# Wisconsin Department of Transportation

**Proposal #29: 4986-00-25, WISC 2022179**  
**C. Fond du Lac, Military Road**  
**Superior Street – Western Avenue**  
**Local Street**  
**Fond du Lac County**

This is Addendum No. 01, which provides for the following:

**ADDENDUM NO. 01**

Addendum No. 01  
 ID 4986-00-25  
 Revised Sheet 148  
 February 2, 2022

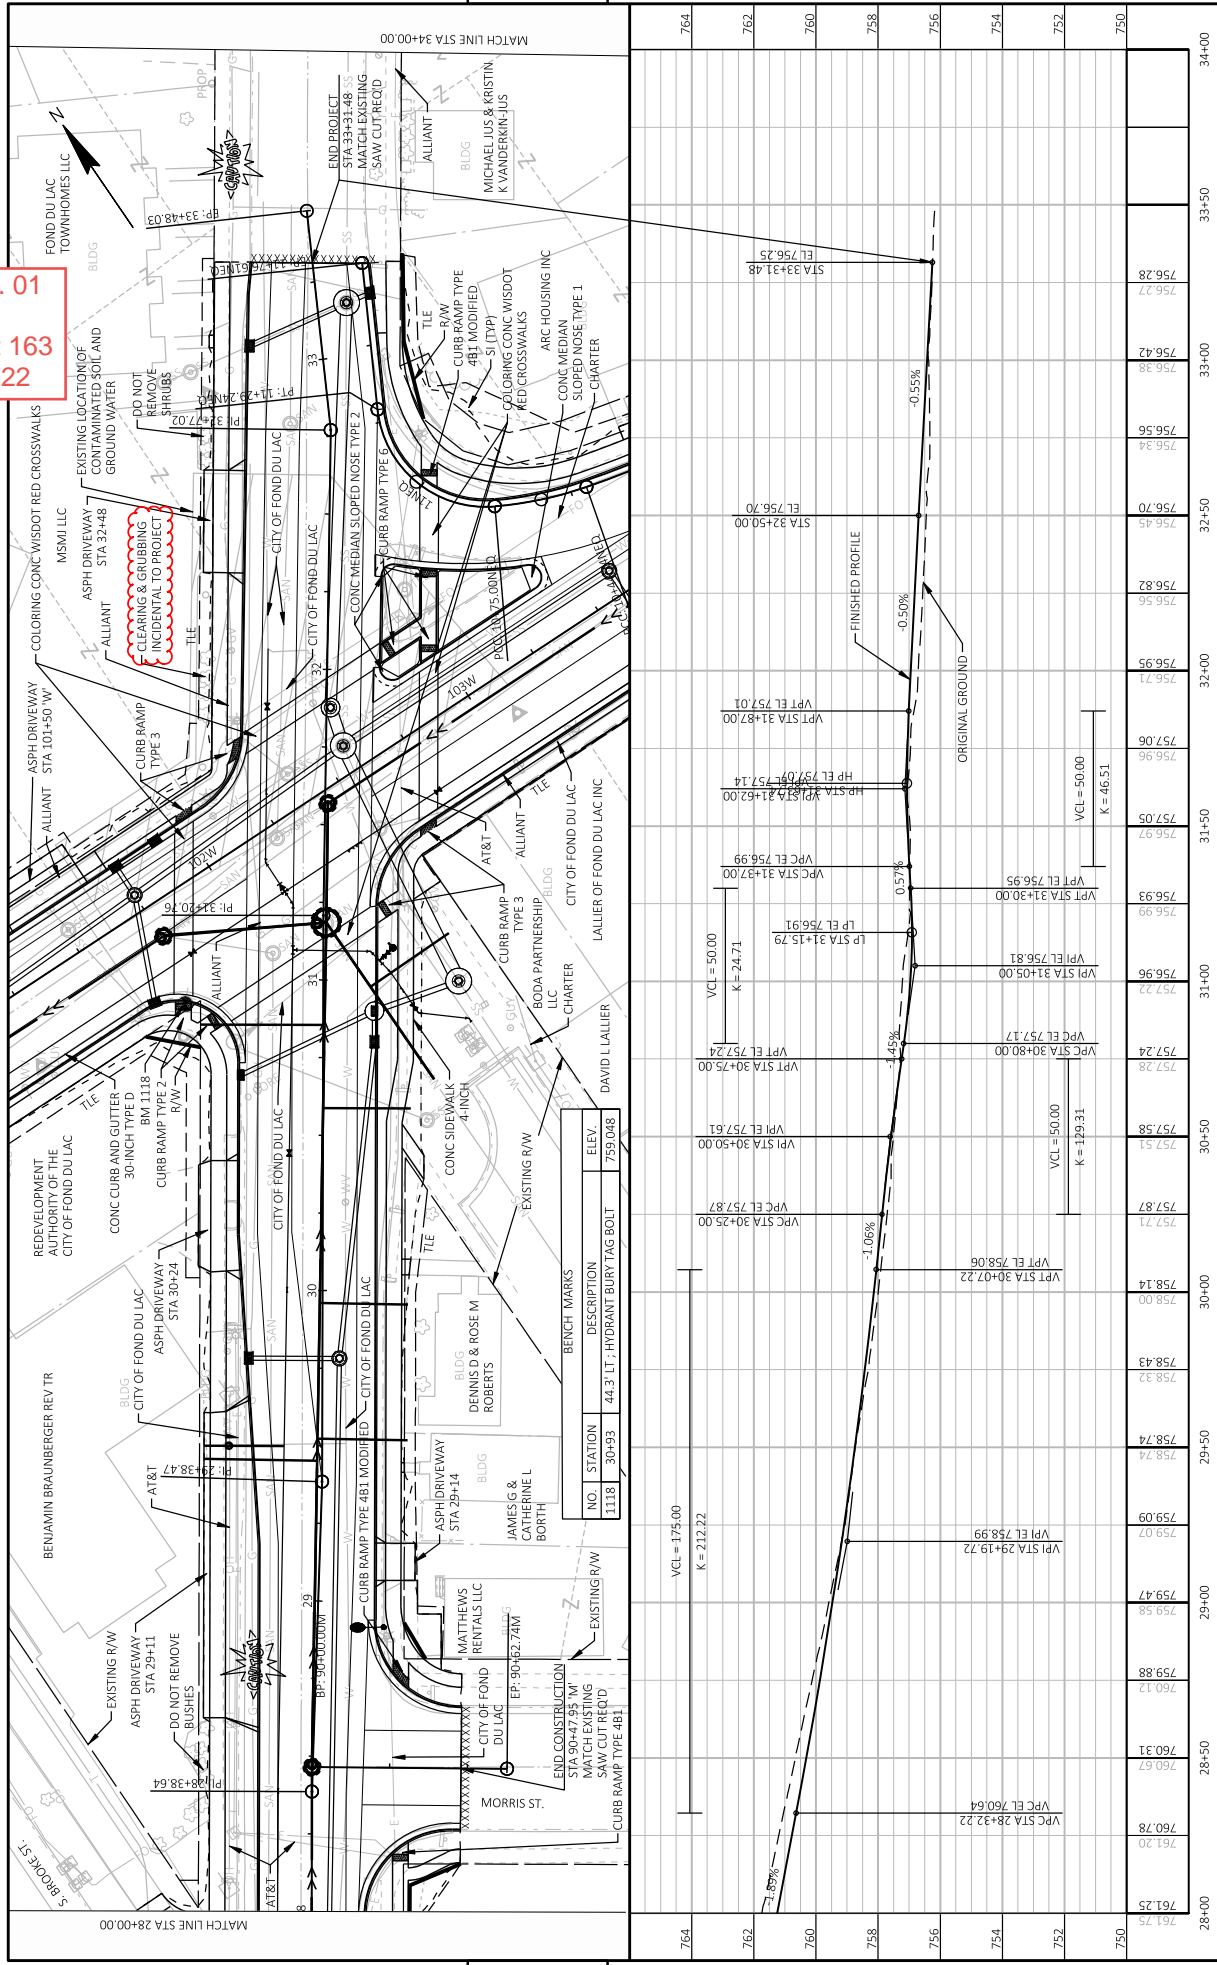
<b>Revised Plan Sheets</b>	
Plan Sheet	Plan Sheet Title (brief description of changes to sheet)
122, 132 & 148	Miscellaneous Quantities (Clearing, Grubbing, Fertilizer Type B updated and SPV.0060.66 added.)
161 & 163	Revised plan and profile to note incidental clearing and grubbing.
